Subject: Fairfield to Dupuyer - Corridor Study, Action ID 199990679

STPP 3-2(27)28
Control No. 4051

This appendix provides a copy of each letter submitted during the comment period on the Draft EIS for this project. This period was initially scheduled between October 18 and December 13, 2002, but due to a failure in the recording equipment at the November 14, 2002 Public Hearing, an extended comment period was offered until February 19, 2003.

Map attachment.

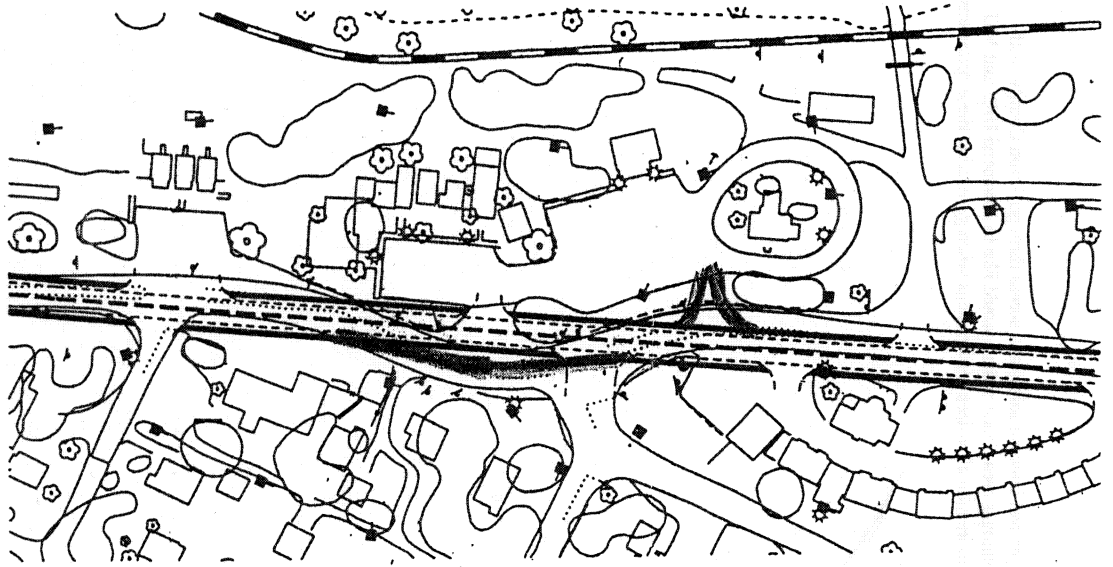
residents at previous meetings, and our observations are that the current condition can pose a potential hazard. This curve can be eliminated with minimal impact to the parking area at the Museum, and is part of the recommendation in the EIS.

Photo attachment

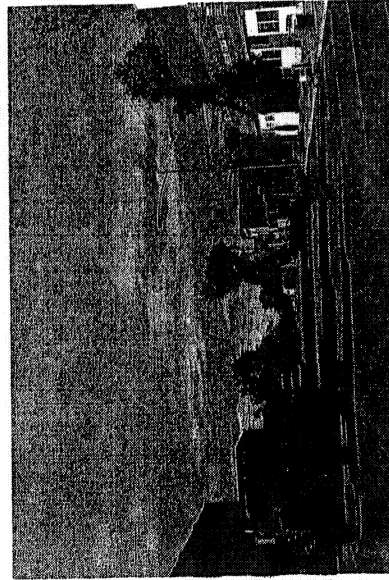
Crosswalk on highway at Choteau. Absolutely no sign exists. School is 8/10 of a mile from crosswalk.

The response at the Public Hearing was that the trees would be unaffected if they were outside the current right-of-way. From the aerial photographs, it appears some trees may be in conflict with the proposed construction limits. Sidelopes can be steepened to avoid the need to remove any mature trees in this area. While this is an element of the final design, the desire to leave as many mature trees as possible at the northern entrance to Choteau will be noted in the conceptual plans developed to date.

Photo attachment

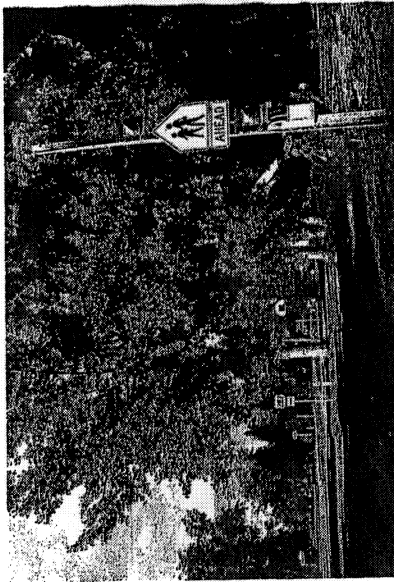
Painted lines on Highway 89 in Choteau. I was led to believe that all of the crosswalks had to be standard painting and signage when I called last month with concerns. The crosswalk by the school in Choteau has very thin lines in an X pattern.

Crosswalk near school in Choteau, only has a flashing school crossing sign at south end of school.

I would like to see a true stop light on Main Street in Choteau, with a "walk" light. I would like our crosswalks CLEARLY marked, particularly on Main Street and near the courthouse. I would also like to see the "kink" in the road remain. I live at 4219 Hwy 89 N and vehicles come by my house going way too fast. I believe the curve helps slow down traffic heading south into Choteau.
